FINAL REPORT
INTERIM REMEDY FOR FIRST
OPERABLE UNIT
SCIENTIFIC CHEMICAL PROCESSING
SUPERFUND SITE AT
216 PATERSON PLANK ROAD
CARLSTADT, NEW JERSEY

FINAL REPORT
INTERIM REMEDY FOR FIRST OPERABLE UNIT
SCIENTIFIC CHEMICAL PROCESSING
SUPERFUND SITE AT 216 PATERSON PLANK ROAD
CARLSTADT, NEW JERSEY

4.0 MODIFICATIONS TO IRRDR

EXTRACTION WELL FINAL WELL RAISING DETAIL
FOR WELLS REQUIRING RAISING FOR FINAL GRADING

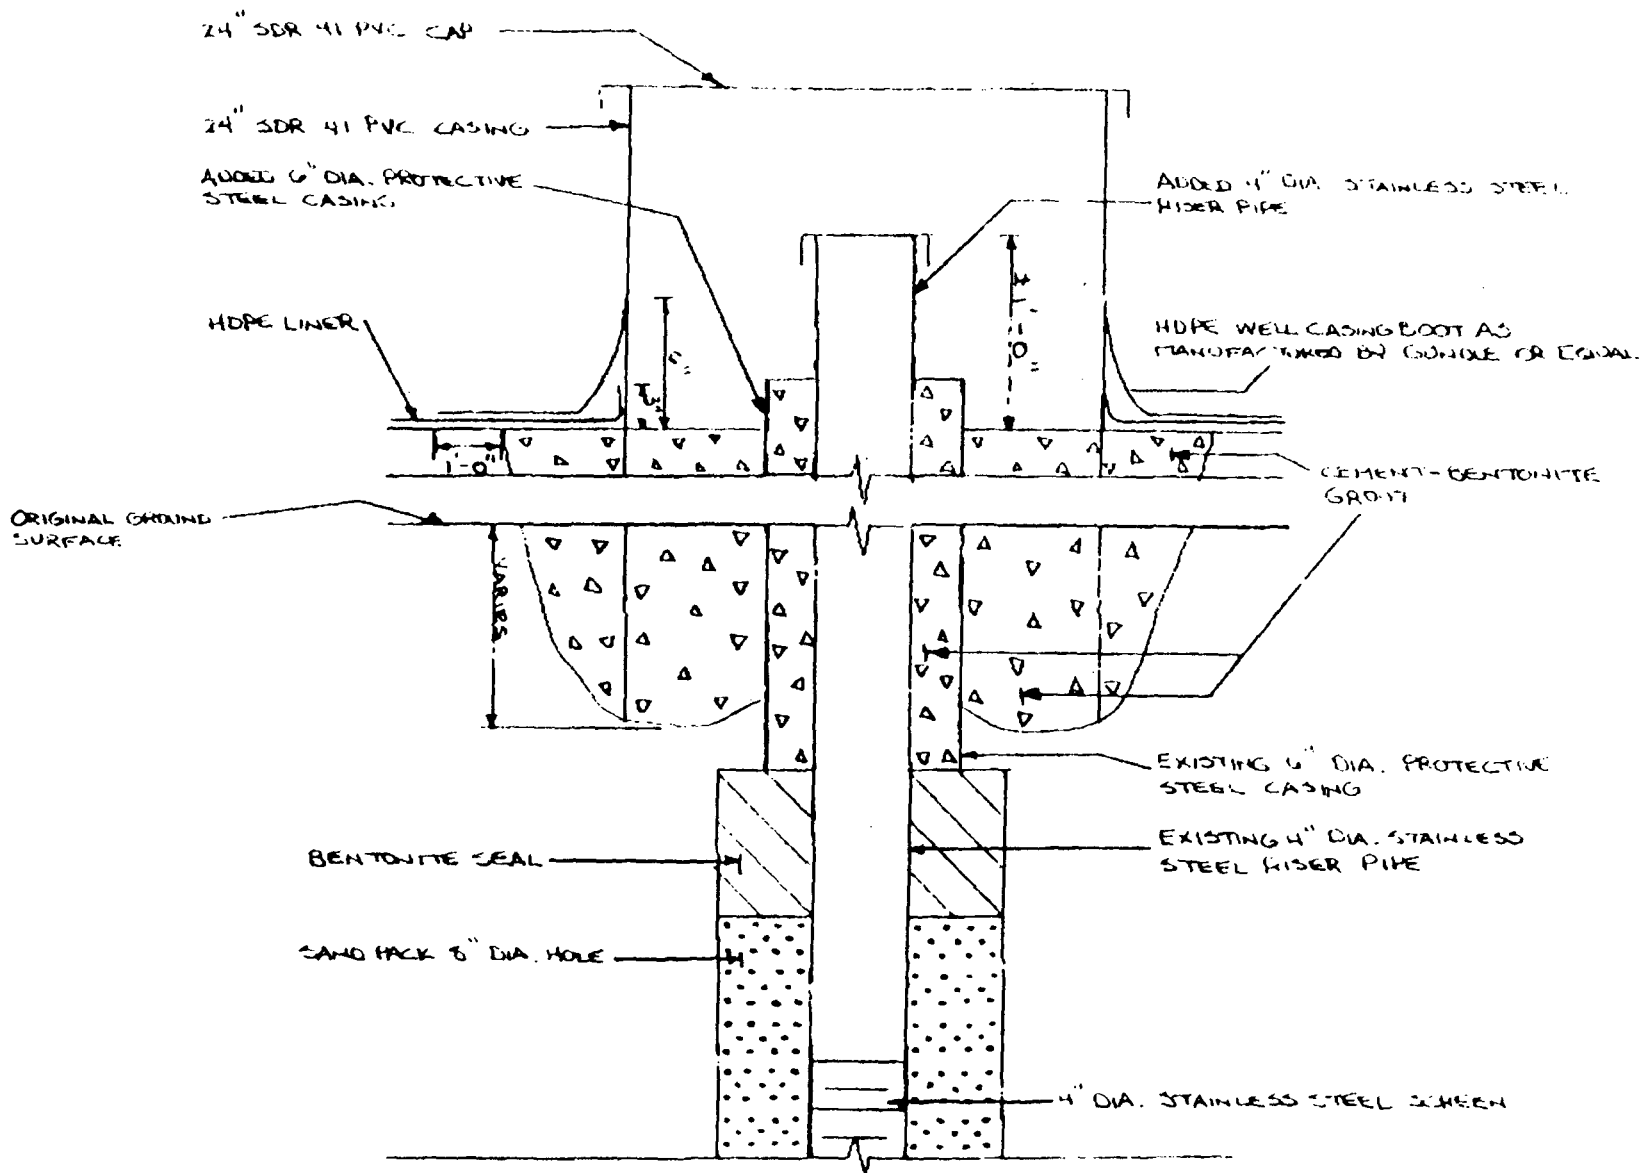
1. Reference the attached Extraction Well Final Well Raising Detail for installation procedures.
2. Repairs proposed at this time include cutting PVC pipe below pinched area and adding 2" diameter threaded or coupled PVC casing; final repair requirements will be determined in the field following excavation around piezometer.
3. Pipes 3, 4, 6 and 8 have not been located in the field; see sheet 2 of the Construction drawings for the locations of Pipes 1, 2, 5 and 7.

1. WHERE APPLICABLE, THIS DETAIL WILL SUPERCEDE THE TWO EXTRACTION WELL FINAL MODIFICATION DETAILS ON SHEET 10 OF THE CONSTRUCTION DRAWINGS.
2. APPROPRIATE WELL HEAD MODIFICATIONS WILL BE INCORPORATED FOLLOWING WELL RAISING FOR THE CONSTRUCTION DRAWINGS.

"LOOPEO" FML BOTTOM ANCHOR DETAIL TYPE 1 - SINGLE WELD CONSTRUCTION

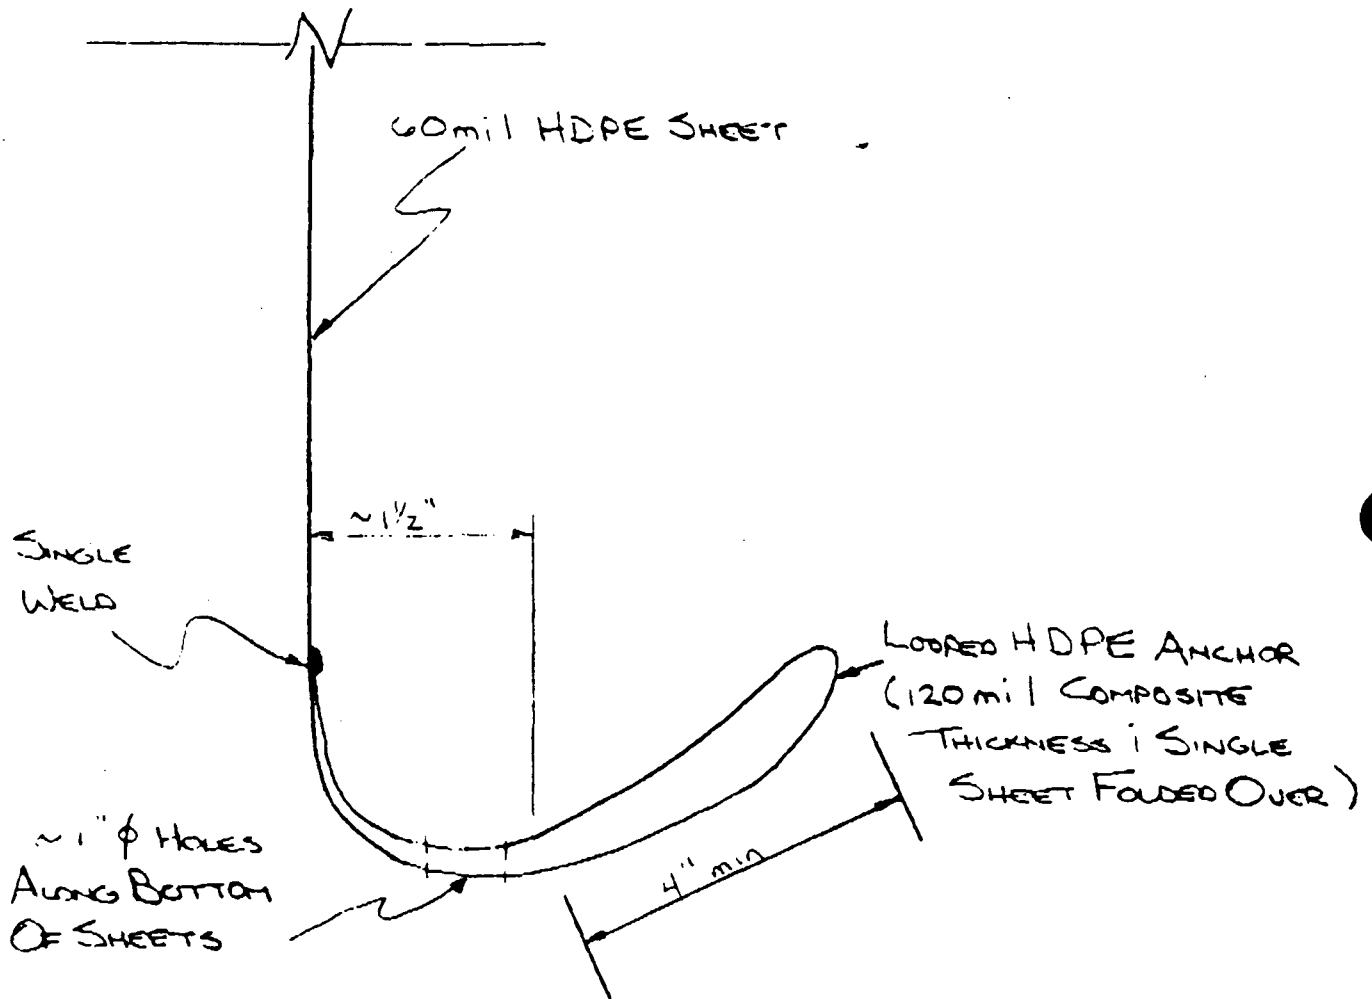
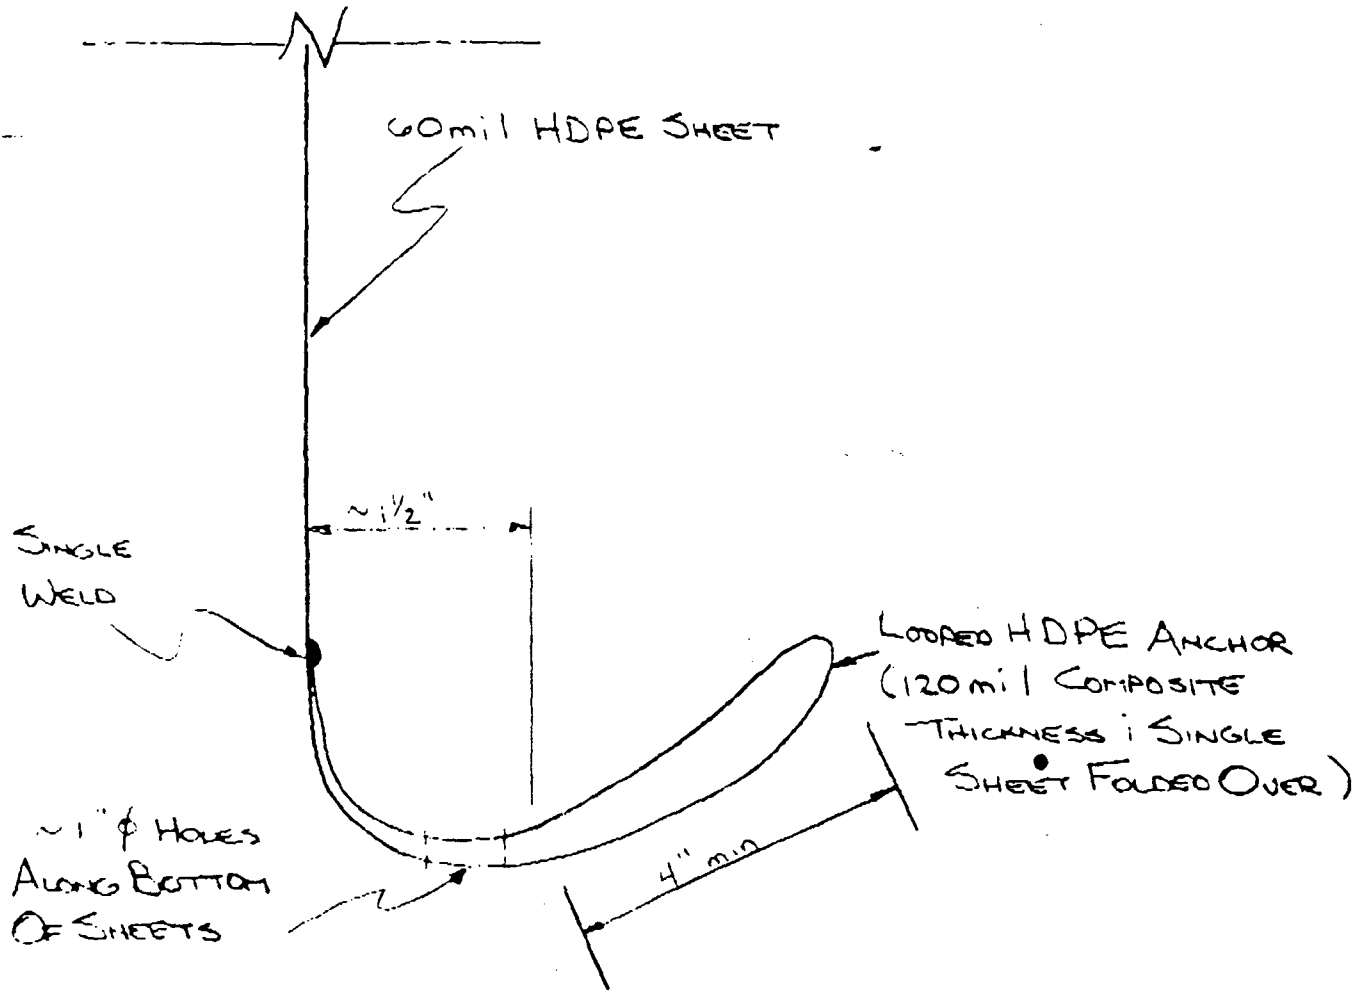
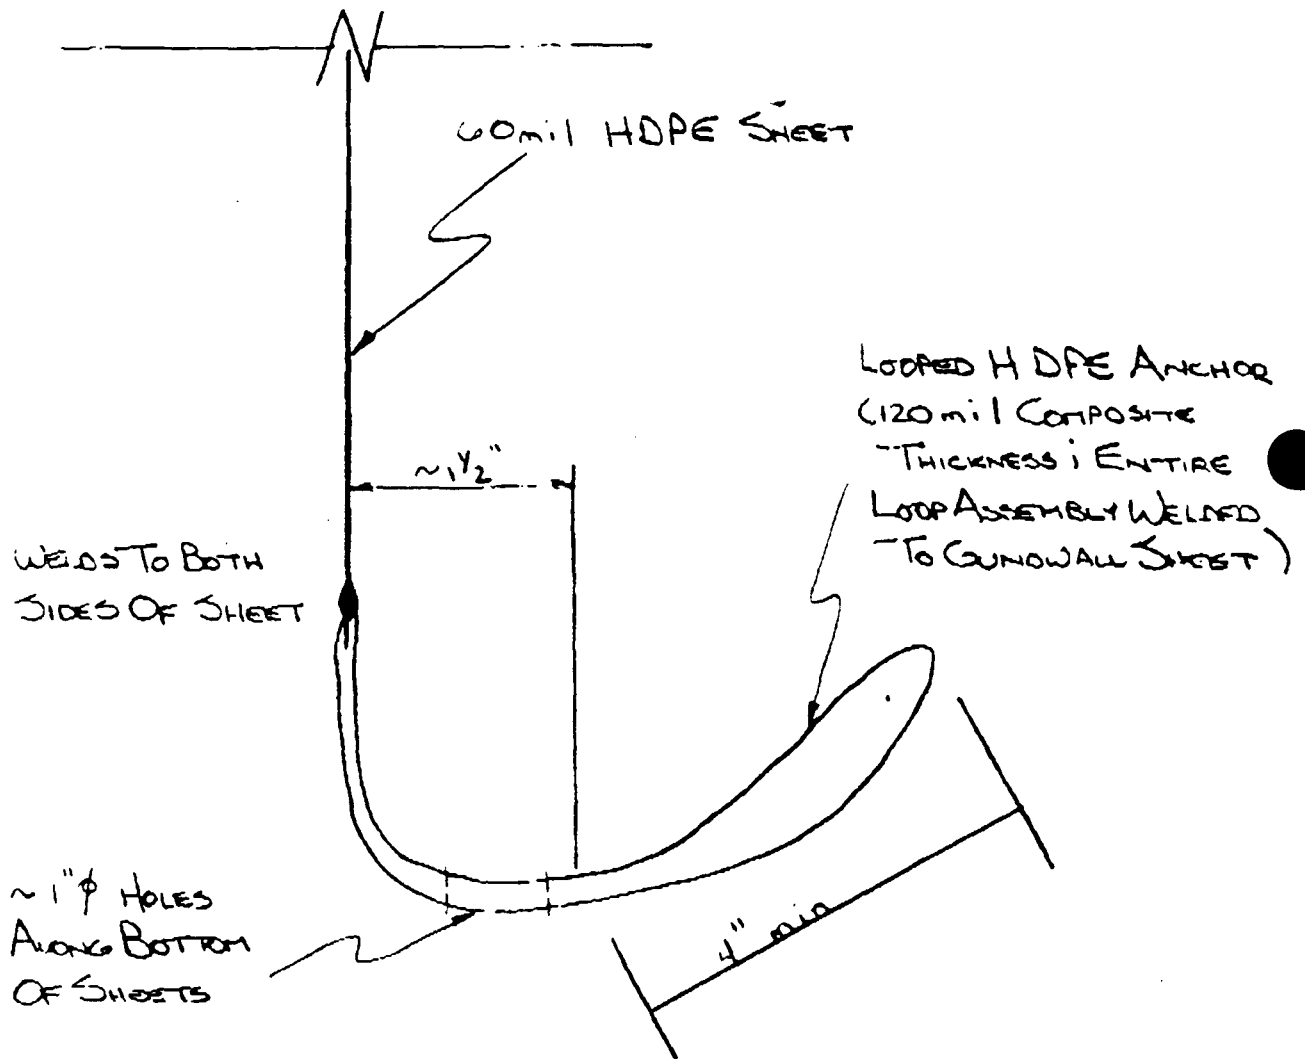
Canonie Environmental Services Corp. (Canonie) requests approval to modify the flexible membrane liner (FML) bottom anchor detail given on Sheet 7 of 14 of the Construction Drawings. Canonie's subcontractor, Gundle Lining Construction Corp. (Gundle), desires to modify the anchor utilizing either a Type 1 or Type 2 "looped" FML bottom anchor as shown on the attached sketches. The "looped" anchor will provide a composite thickness of approximately 120 mil (approximately 1/8-inch) in place of the 1/4-inch thickness called for on the anchor detail. However, the "looped" anchor will have the added advantage of being more flexible due to the thinner section, therefore allowing it to fit the tip of the insertion plate more securely. Because the adherence of the Gundwall sheet to the insertion plate is the controlling factor in successfully driving the Gundwall sheets, the "looped" anchor is a more desirable installation method.

By HH Date 12/19/91 Subject SCP CARLSTADT Sheet No. 1 of 10
 Chkd. By CC Date 12-19-91 SHEETPILE WALL SUPPORT Proj. No. 70-198
 1/4" X 1/4"

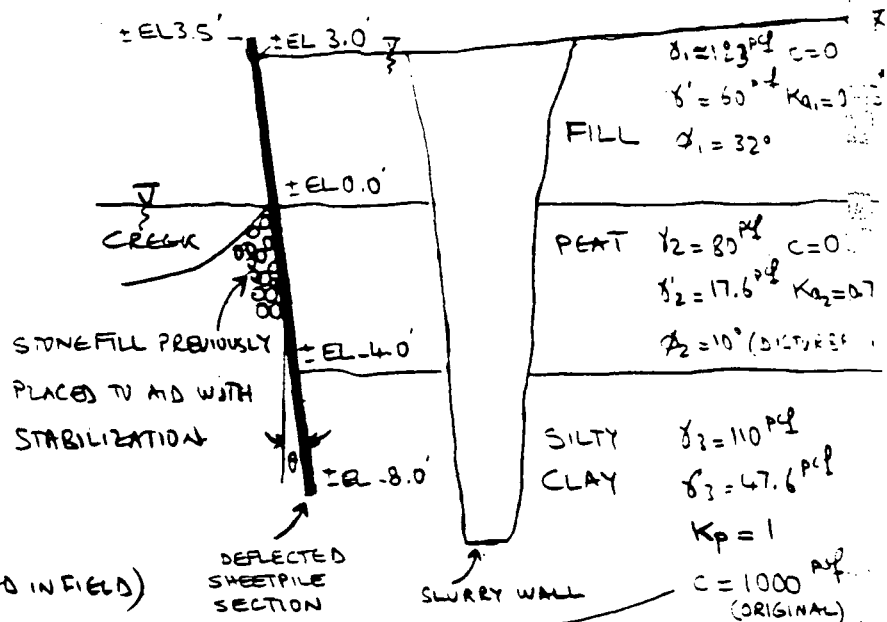
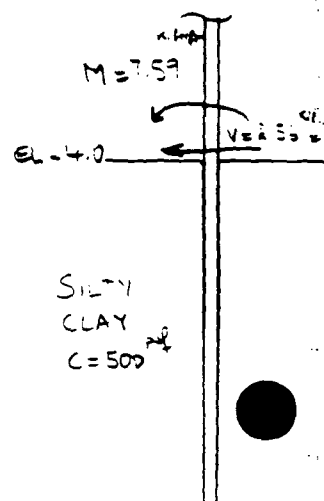
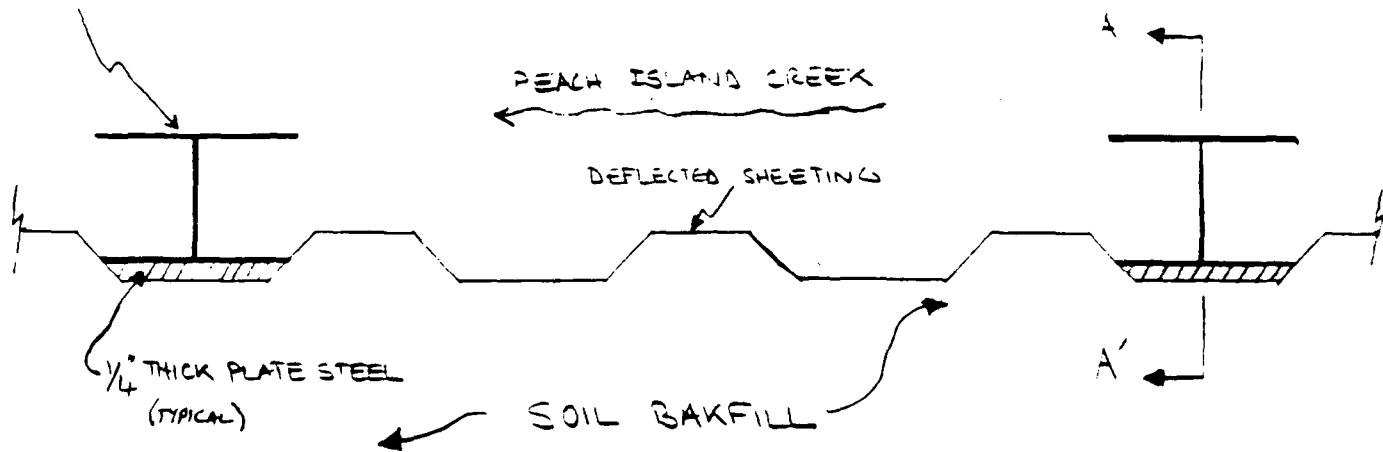
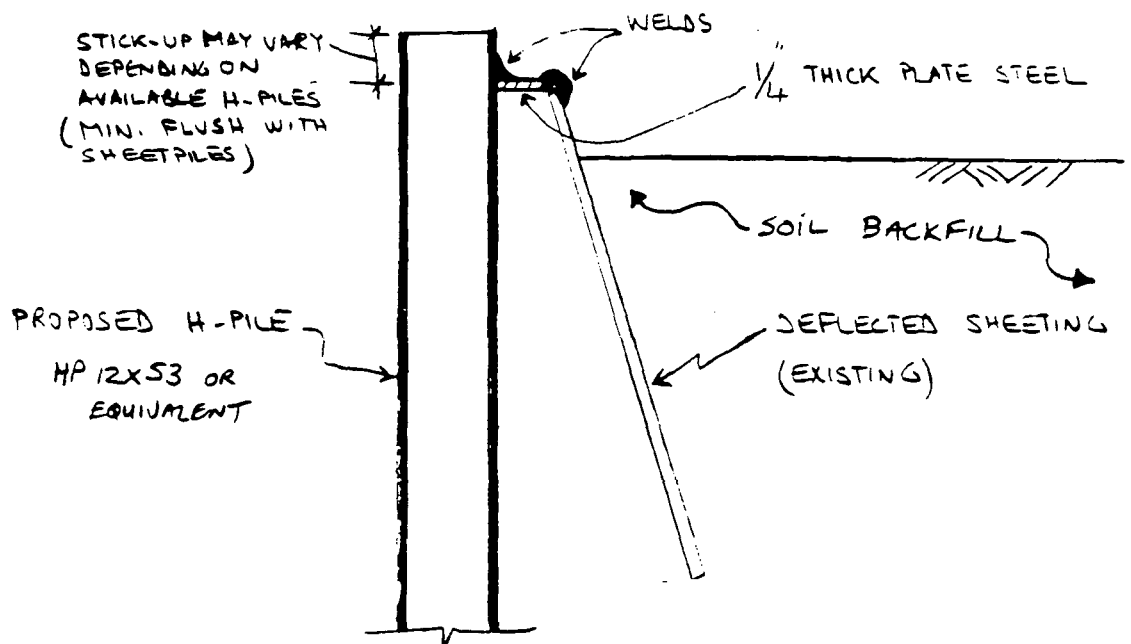
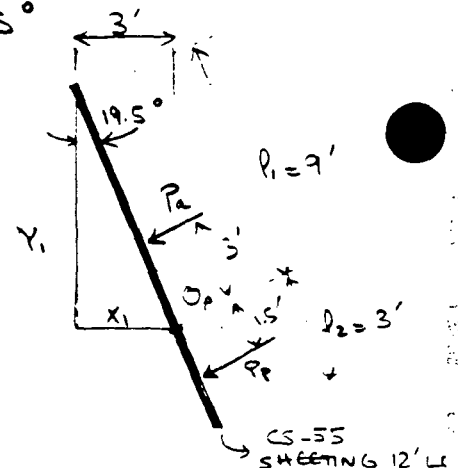
1. Leave the two sections of sheet pile wall (Sheets 155 to 170 and Sheets 181 to 191) in their current deflected position. Canonie has already placed the proposed riprap material along the creek side.
2. Install H piles along the creek side of the deflected sheet pile sections to provide additional support. Calculations showing that there is sufficient stability with this configuration are attached.

THE FOLLOWING BRACING METHOD WILL BE UTILIZED TO PROVIDE ADDITIONAL SUPPORT TO THE DEFLECTED SHEETPILE WALL SECTIONS FROM STA. 3+53 TO 3+90 (SHEETS 155 TO 170) AND STA. 4+15 TO 4+38 (SHEETS 181 TO 191). THESE CALCULATIONS SHOW THAT THIS BRACING METHOD WILL PROVIDE A SUFFICIENT FACTOR OF SAFETY FOR STABILITY OF THE SHEETPILE WALL.

USE HP 12x53 OR EQUIVALENT

$$S_x = 66.8 \text{ in}^3 > 56.7 \quad \underline{\text{OK}}$$

PROPOSED MODIFICATION TO FENCING LAYOUT

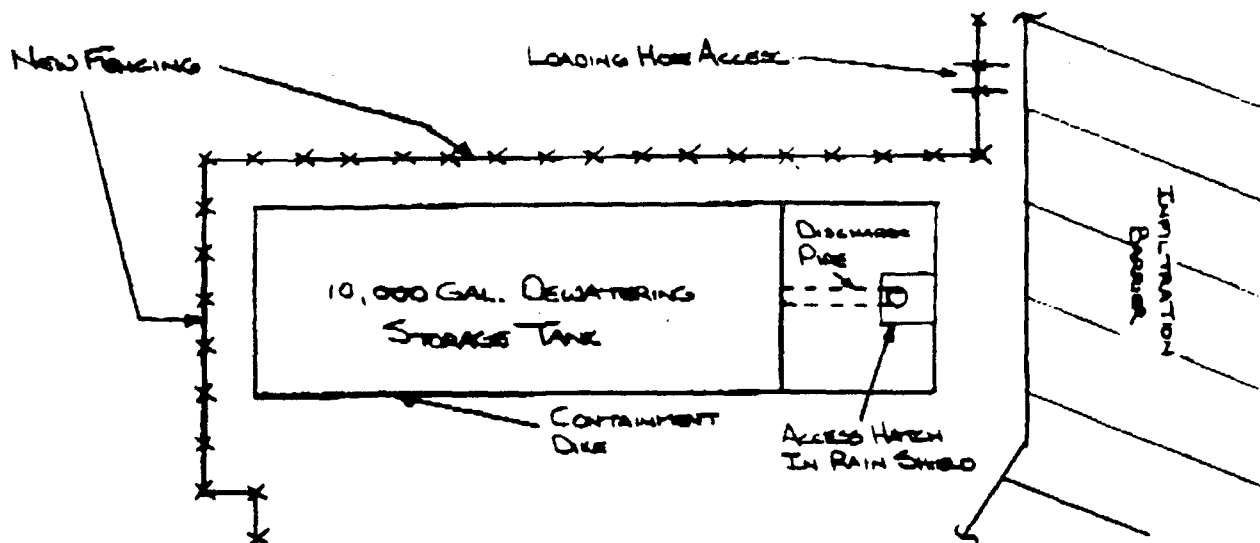
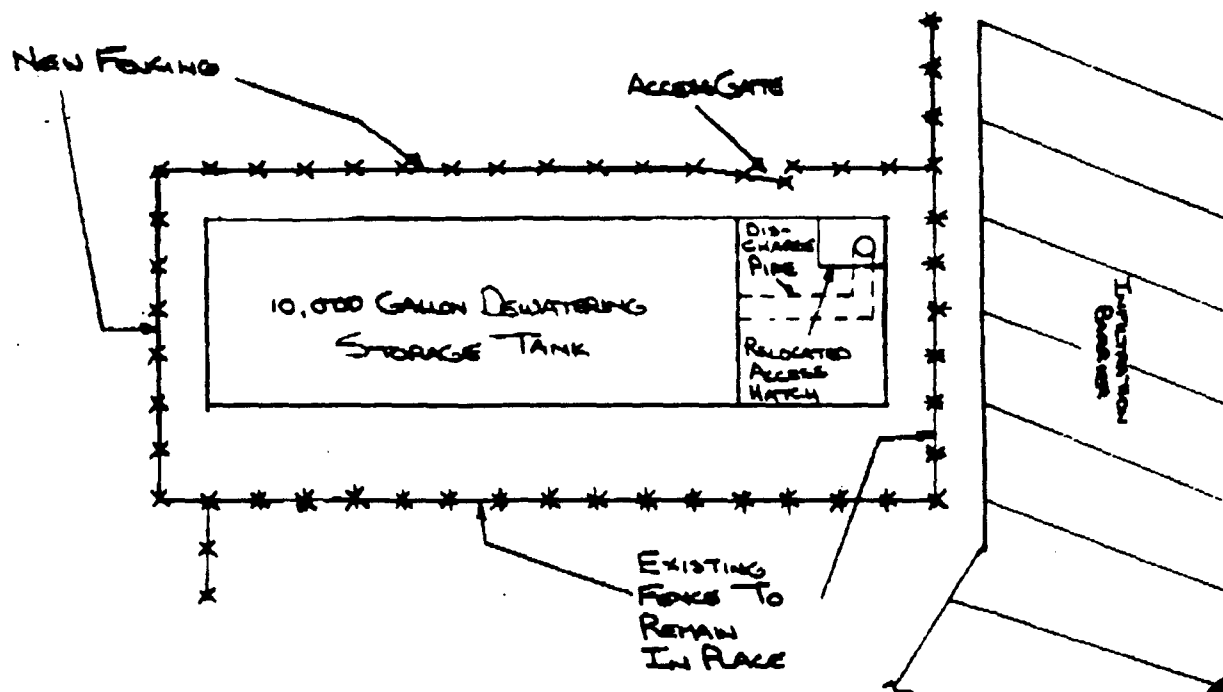
By FUG Date 1/30/92 Subject MODIFICATION TO FENCING LAYOUT Sheet No. 1 of 1

EXISTING FENCING LAYOUT PER DWG. 11 OF 14

NOTE: THE DISCHARGE PIPE CONNECTION WILL HAVE A MINOR MODIFICATION TO REALIGN ITS POSITION WITHIN THE SECONDARY CONTAINMENT AREA. THIS MODIFICATION TO THE DISCHARGE PIPE SIMPLY INVOLVES ADDING A 90° ELBOW AND SHORT SECTION OF PIPE.
